TRANSMITTAL OF INFORMATION ON CHANGES TO THE IT CORPORATION DESIGN AS REFLECTED IN THE DRAFT REMEDIAL DESIGN DOCUMENTS PACKAGE FOR OPERABLE UNIT 1

Reference: Draft Remedial Design Documents Package for Operable Unit 1, as Developed by IT Corporation, dated March 1998.

# CHANGES TO THE OU1 DRAFT REMEDIAL DESIGN DOCUMENT

WASTE PITS REMEDIAL ACTION PROJECT (WPRAP)
FERNALD, OHIO
FDF SUBCONTRACT NO. 985C000001

DRAWING NUMBER D-60-10-001

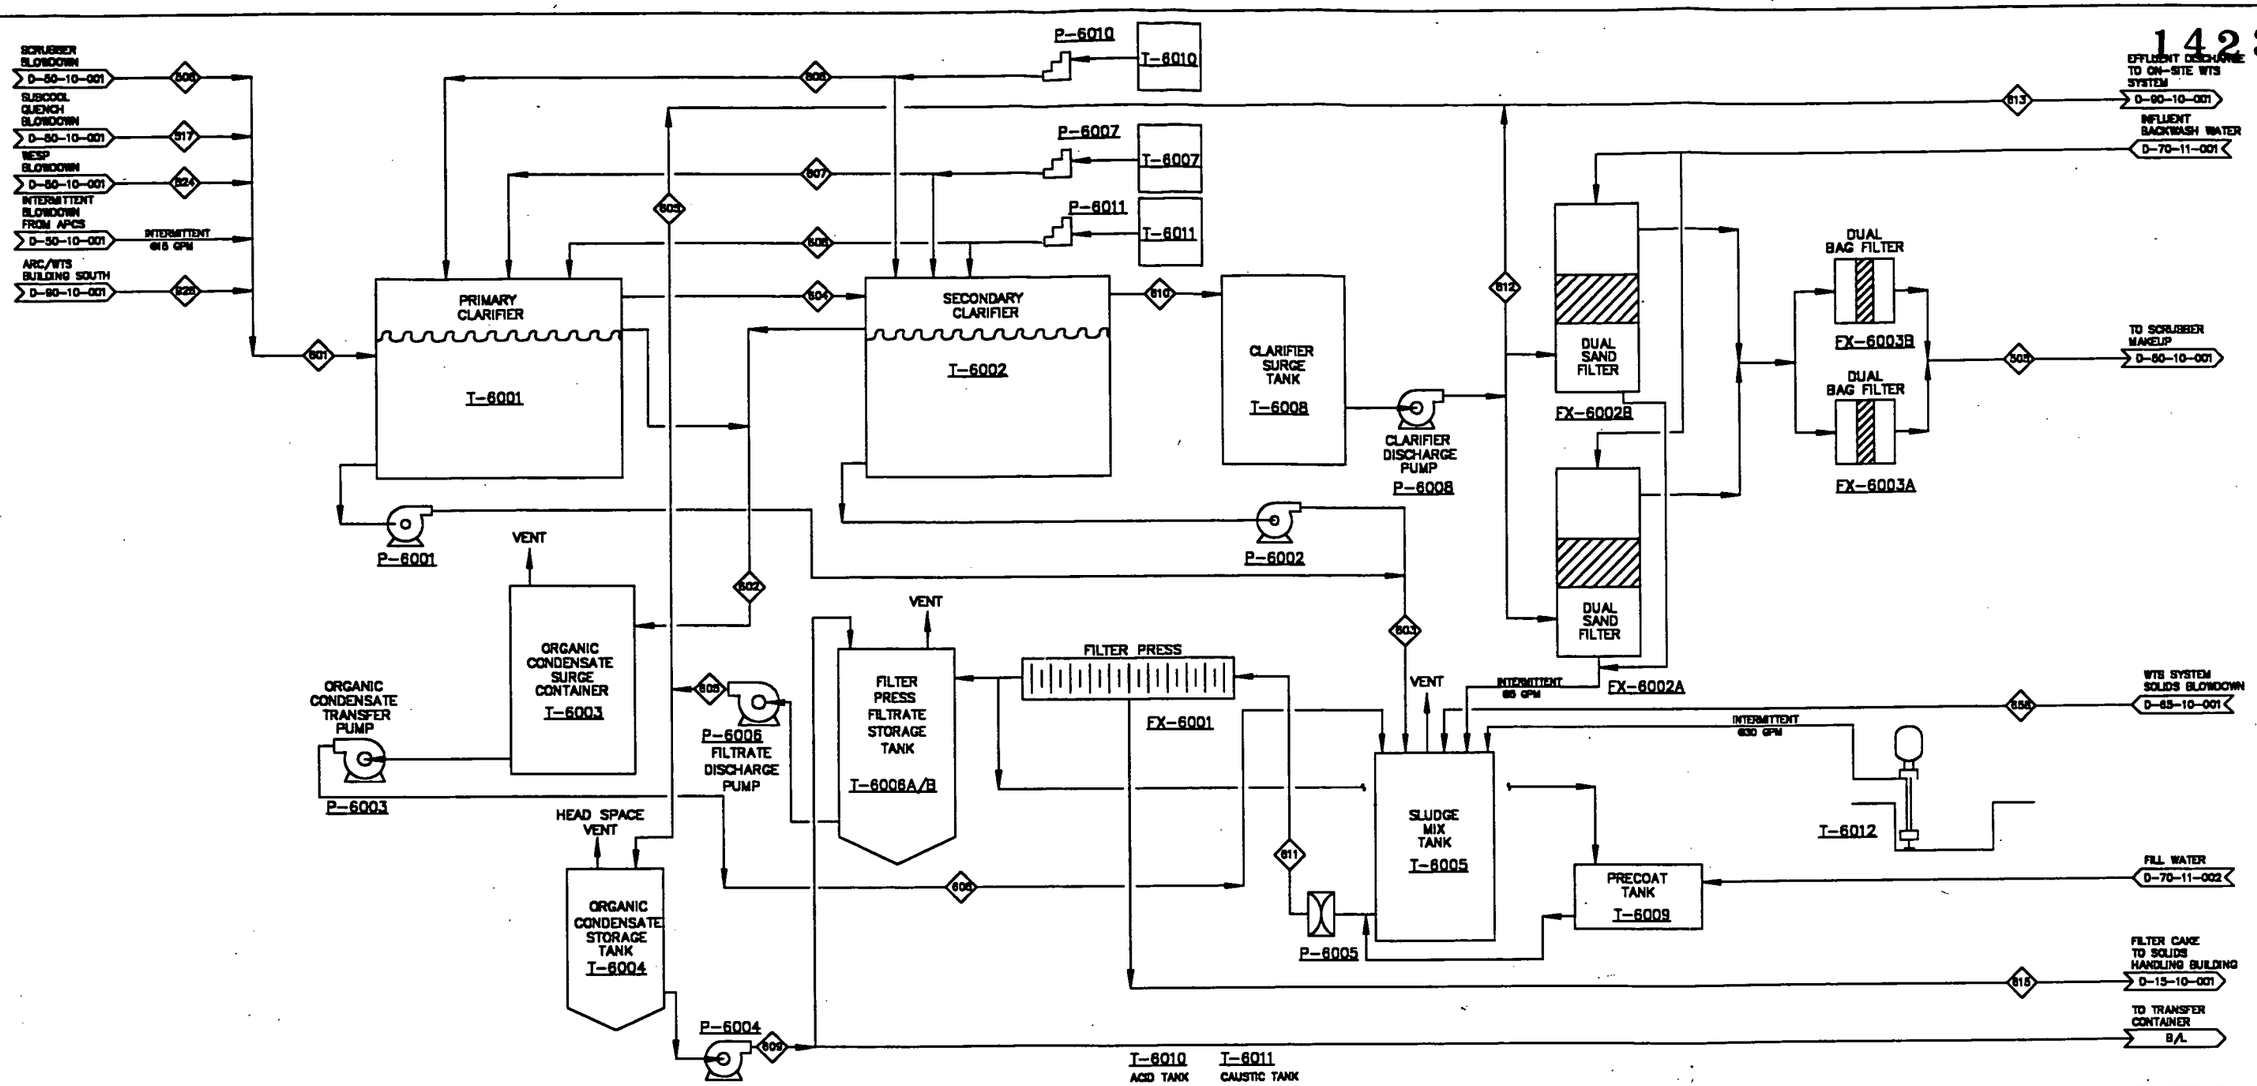
4) **Gas Cleaning System blowdown directed to Clarifiers/Filters in lieu of hydroclones:**

Rev. B of the RD Documents Package incorporated hydroclones (see PFD D-60-10-001, Rev. B) to remove only solids from the gas cleaning system blowdown. Based on the design verification testing, both free phase and soluble organics will be present in the gas cleaning system blowdown stream along with particulate solids. The revised design includes a primary and secondary clarifier, and dual sand/bag filters (see PFD D-60-10-001, Rev. D). The clarifiers will handle the removal of free phase organics as well as solids versus the hydroclone capability of handling only solids separation. Additionally, a filter press will be required to handle clarifier sludge dewatering requirements.
